Re: 2-4 John Street, Camden

DA s4.56 Modification: 2008/644/5¹

Consolidation of buildings 3 and 5 into one building, conversion of 26 multiple-unit dwellings into 26 self-contained seniors living dwellings, conversion of 2 shops into 2 self-contained seniors living dwellings, internal layout reconfiguration to provide 2 additional self-contained seniors living dwellings, reconfiguration of the lower ground floor car park underneath buildings 3, 4, 5 and 6 and replacement of a turning circle with a pedestrian path

**Source: Extent Heritage Sydney
March 2021 Statement of
Heritage Impact Building 3+5, 2-
14 John St, Camden (p. 29)**

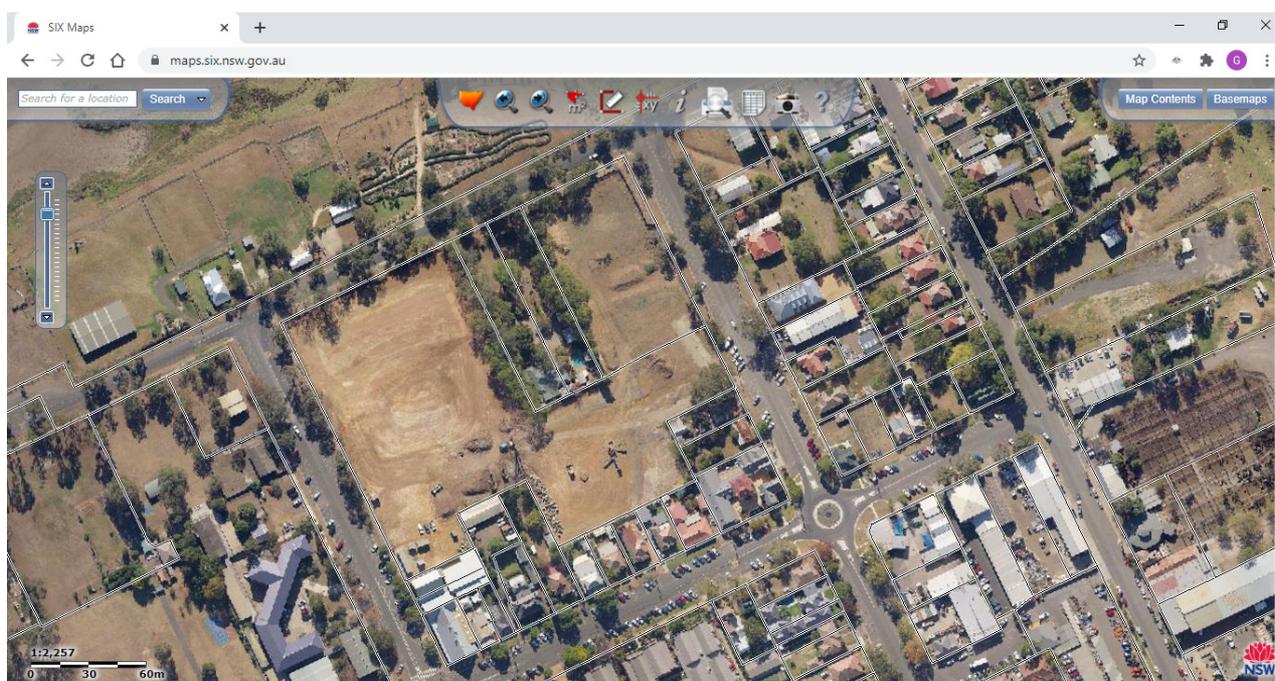
Clearly the proposed street façade of John Street does not read as two-storeys, and the proposed building(s) are not compatible in form and height with the surrounding built form of the conservation area. They are not fine-grained and human scale as required by the DCP and Urban Design Framework. The design of the building(s) cannot be judged to be consistent with any building style in John, Elizabeth, Exeter and Mitchell Streets. The top storey(s) is (are) not set back. The building set back from John Street is not able to be determined but appears minimal. The contextual and comparative scale is massive and not minimised.
